**Community Environmental Response  
Facilitation Act (CERFA) Report  
Fort Wingate Depot Activity  
Gallup, New Mexico**

**U.S. Army Environmental Center  
Response to Regulatory Comments  
Fort Wingate Depot Activity Draft CERFA Report**

**U.S. Army Environmental Center  
Response to Internal Army Comments (Requested by the State of New Mexico Environment Department)  
Fort Wingate Army Depot Activity Draft CERFA Report**

<b>Fig 5.1-1</b> <b>Category and Designation Map</b>		DRAWING NO.	
		<b>Figure 5.1-1</b>	
		REV. NO.	
12.11.93/04.10.94	CLIENT APPROVAL		
PM307.70.01/1401-1	ISSUED FOR	DATE	SHEET 1 OF 4

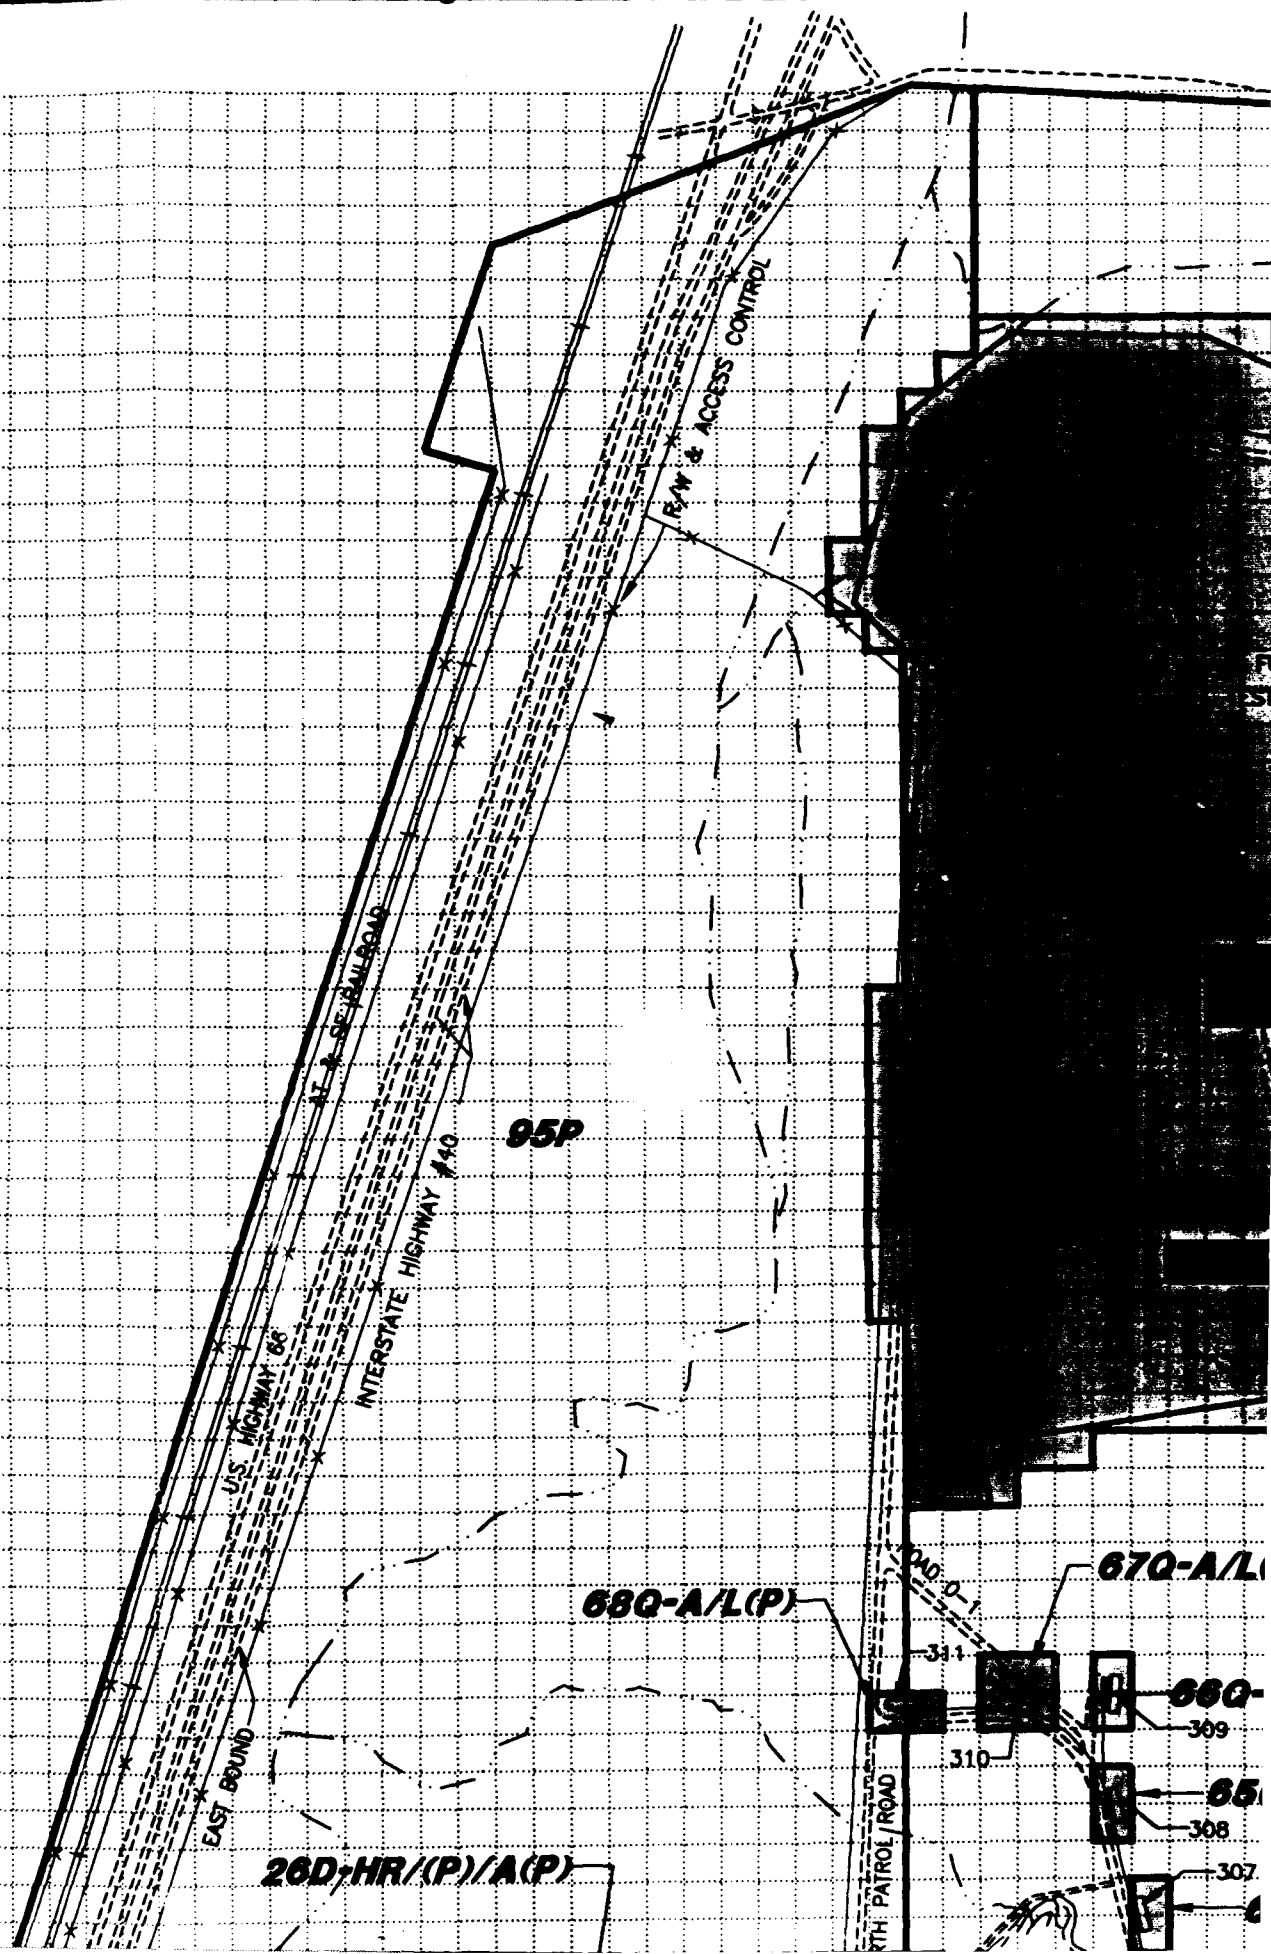
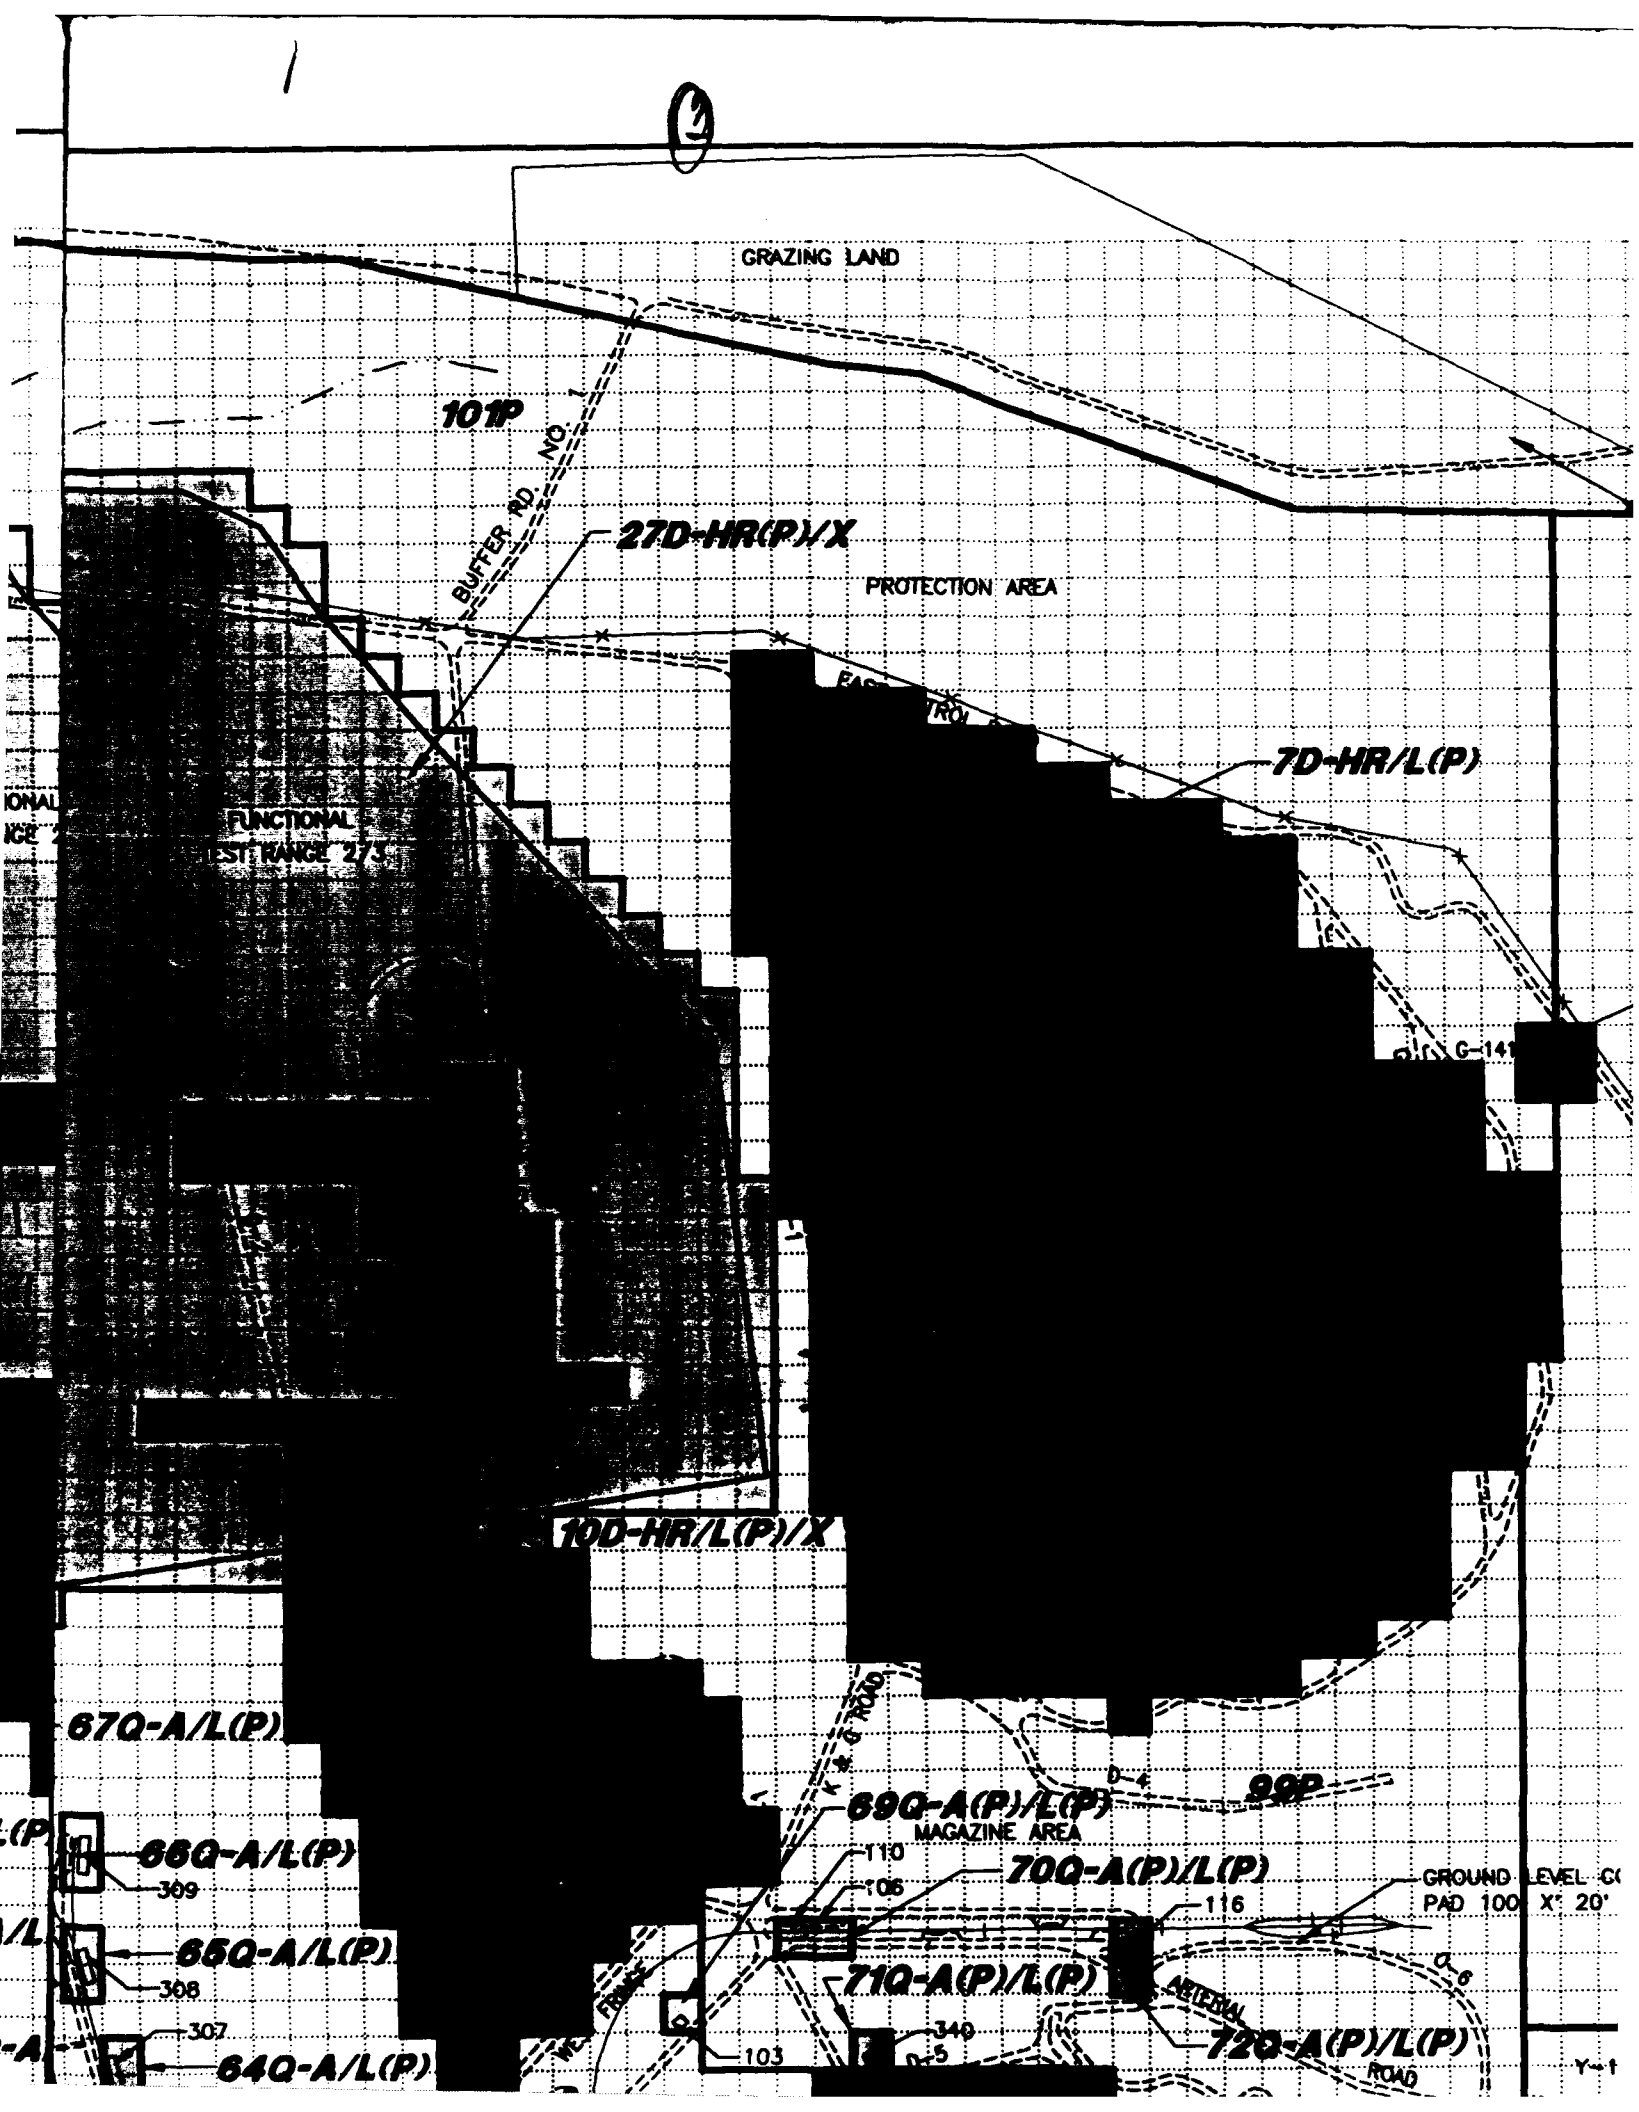
Comment: All maps provided as Figure 5.1-1 should be peer reviewed and approved with the appropriate signature sign off provided in the QA/QC block.

Recommendation: Revise the Figure 5.1-1 maps in accordance with the provided comment.
